# HISTORIC CONSERVATION BOARD AGENDA

Monday, November 21, 2016 at 3:00 pm

**APPLICATION FOR  
CERTIFICATE OF APPROPRIATENESS  
HISTORIC CONSERVATION BOARD PUBLIC HEARING  
STAFF REPORT**

1 EAST ELEVATION - PROPOSED  
SCALE: 1/4" = 1'-0"

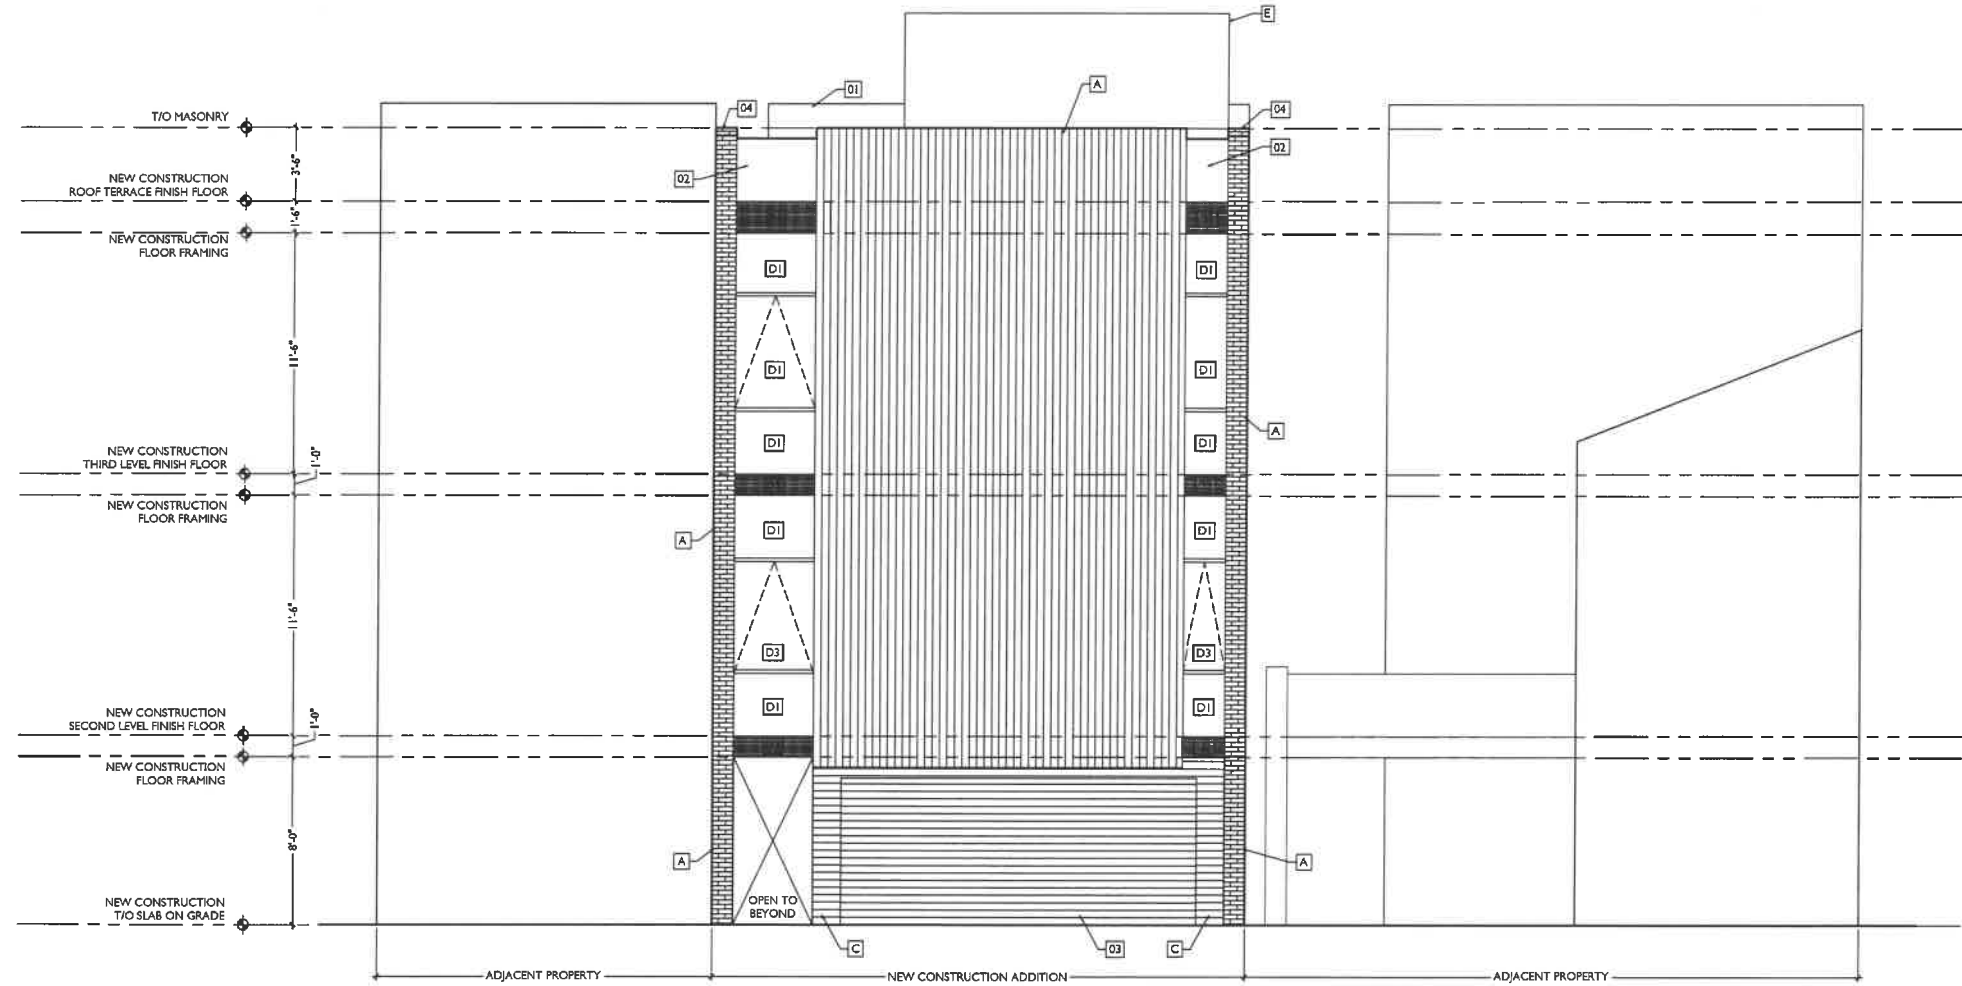
A Certificate of Appropriateness is required the rear addition. The addition is not highly visible from the street and substantially conforms to the guidelines with the exception of the vertically oriented cedar plank siding on the rear. While this is not visible to surrounding streets, as there is a public alley, we need to be cognizant that we are keeping perspective of the historic facades that are visible on alleys. Having both curtain walls on the edges and the vertical plank siding are two very contemporary treatments. It would be more appropriate to introduce just one subtle design element rather than have an entire façade that is not in keeping with the context. Staff feels that the horizontal oriented cedar plank siding would be more contextual and appropriate.

*The materials that are being used on the addition include masonry and cedar siding. The cedar siding on the north elevation is horizontal in configuration whereas the cedar planks on the rear façade are vertical in configuration. While this material is appropriate the orientation is not an appropriate treatment. The cedar plank siding should be oriented horizontally.*

1. The cedar plank siding on the rear/east façade shall be horizontal in orientation.
2. The building permits must be issued within two years of the decision date or the Certificate of Appropriateness shall expire.
